TITEL: Kontroll av stjärtrotorväxel

GÄLLER: Bell Helicopter Textron Canada Modell 407.

Subject: Bell 407 □ Tail rotor gearbox

SUBJECT: REVISION "C" TO ALERT SERVICE BULLETIN 407-97-14, TAIL ROTOR GEARBOX P/N 406-040-400-ALL, TORQUE CHECK AND INSTALLATION PROCEDURES, MODIFICATION OF.

Figure 1. Paint – Removal.

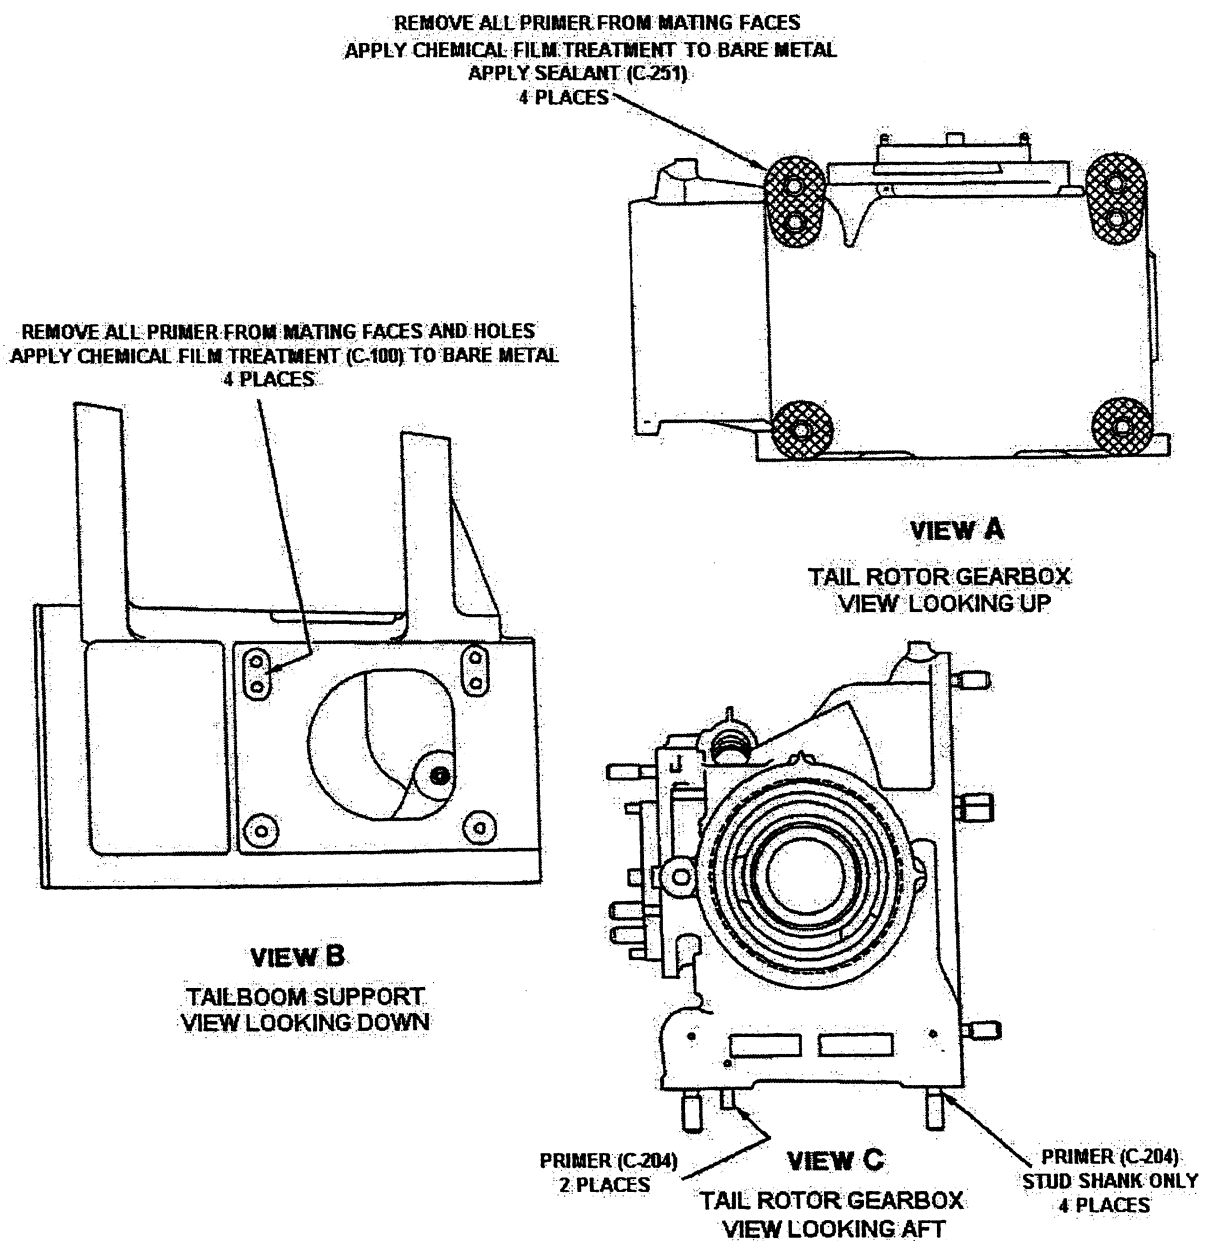
4. Enlarge the two dowel pin holes of tailboom support as follows (Figure 2):
 - a. Remove the primer from the areas (Figure 1, View B) with paint remover. Refer to the BHT-ALL-SPM, Chapter 4. As an alternative procedure, you can use Plastic Media Blasting to remove the paint. Refer to BHT-ALL-SPM, Chapter 3.

5. Remove the paint and the primer from the areas (Figure 1, View A) with paint remover. Refer to the BHT-ALL-SPM, Chapter 4. As an alternative procedure, you can use Plastic Media Blasting to remove the paint. Refer to BHT-ALL-SPM, Chapter 3.

6. Apply Chemical Film Treatment to areas as per Figure 1, View A. Refer to BHT-ALL-SPM, Chapter 3, under bolded title **Magnesium Touchup Treatment Solution**.
7. Make sure that the four (4) stud holes and the two (2) dowel pin holes do not have primer in them.
8. Install the tail rotor gearbox as follows:
 - a. Clean with solvent (C-305) the surface of the tailboom support where you install the tail rotor gearbox (View A).
 - b. Apply primer (C-204) to the two (2) dowel pins and the shank of the four (4) studs shown in Figure 1, View C. The tail rotor gearbox must be installed on the tailboom support while the primer is wet.
 - c. Apply sealant (C-392) to the areas shown in Figure 1, View A.

Figure 2. Tailboom – Modification.

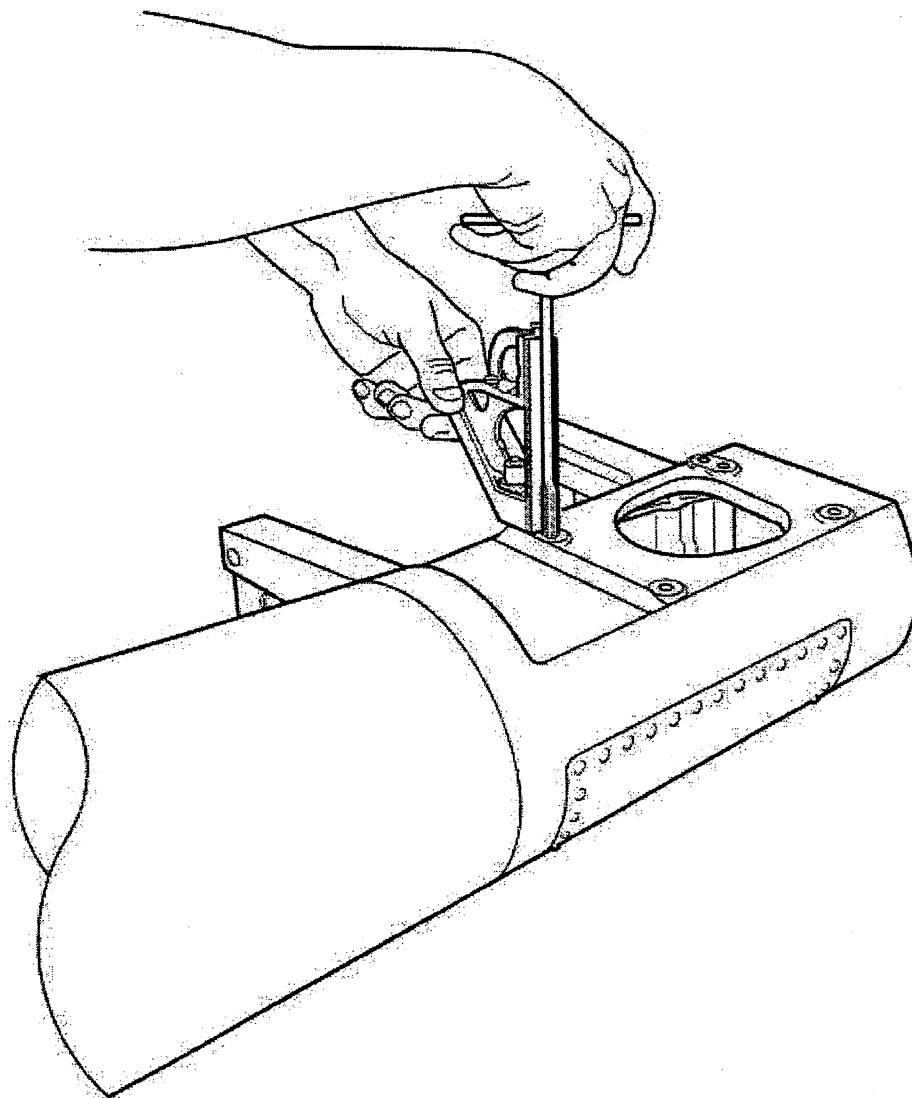
- b. Use a machinist square, Snap On PMF122 or equivalent, to maintain reamer perpendicular to the dowel pin holes as shown in Figure 2.
 - c. Ream the dowel pin holes between 0.257 to 0.259 inch diameter.

- d. Inspect the area with a 10 magnifying glass for cracks.
 - e. Apply Chemical Film Treatment (C-100) to the dowel pin holes.
 - f. Re-identify the tailboom support as follows:

407-030-833-~~101~~-103

Figure 3. Work aid – Field fabricated.

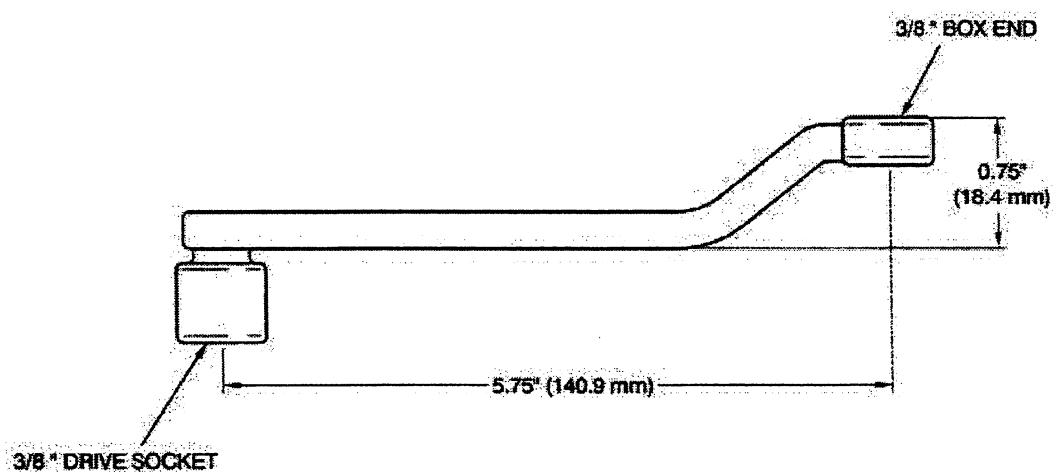
- d. In less than 15 minutes after you apply the sealant, apply torque of 140 to 160 inch-pounds (15.8 to 18.0 Nm) to the four (4) nuts that attach the tail rotor gearbox. Use the tail rotor gearbox work aid, Figure 3, to install the aft left hand nut.
 - e. Complete the installation of the tail rotor gearbox. Refer to BHT-407-MM-7, Chapter 65.
 - f. One hour after you torque, apply torque of 140 to 160 inch-pounds (15.8 to 18.0 Nm) again to adjust for the movement of the sealant .
9. Make an entry in the helicopter historical records to show that you have completed Part I of this Alert Service Bulletin.
 10. Make an entry in the Alert Service Bulletin section of the Maintenance Manual to show that Part I of this Alert Service Bulletin has been accomplished.
